Sundry Print Report
11/06/2023

Well Name: RAGIN CAJUN 12-13 FED COM	**Well Location:** T26S / R34E / SEC 12 / NWNE / 32.063668 / -103.421547	**County or Parish/State:** LEA / NM
Well Number: 13H	**Type of Well:** OIL WELL	**Allottee or Tribe Name:**
Lease Number: NMNM100567	**Unit or CA Name:**	**Unit or CA Number:**
US Well Number: 3002547555	**Well Status:** Approved Application for Permit to Drill	**Operator:** DEVON ENERGY PRODUCTION COMPANY LP

Type of Submission: Notice of Intent

Type of Action: APD Change

WELL LOCATION AND ACREAGE DEDICATION PLAT

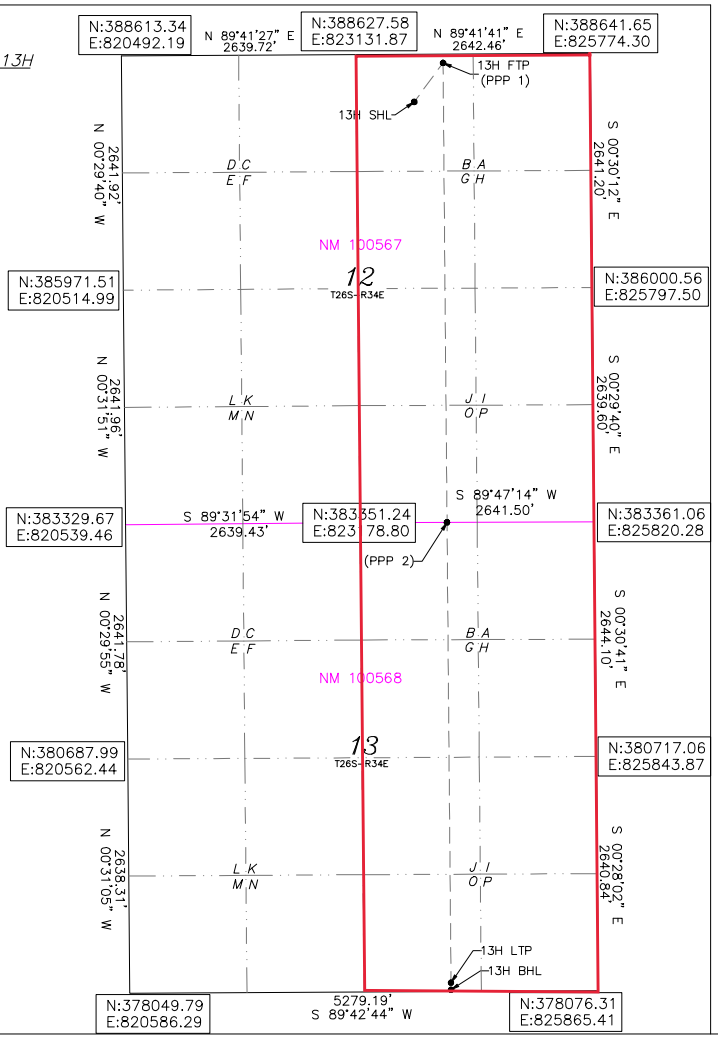
BHL change from 20 FSL & 1300 FEL to 20 FSL & 1660 FEL, both 13-26S-34E.
TVD/MD change from 12,795/23,078 to 12,773/22,952
Casing program change: Surface, Intermediate, & Production casing changes. Cement volume changes to accommodate casing change.
Defining well designation change to Ragin Cajun 12-13 Fed Com 11H

Please see attached revised C-102, and drilling & directional plans.

UL or lot No.	Section	Township	Range	Lot Idn	Feet from the	North/South line	Feet from the	East/West line	County
O	13	26-S	34-E		20	SOUTH	1660	EAST	LEA

LAST TAKE POINT
100' FSL 1660' FEL SEC. 13
N:378167.97
E:824204.57
LAT:32.036378
LON:103.420480

BOTTOM OF HOLE
N:378087.97
E:824205.26
LAT:32.036158
LON:103.420480
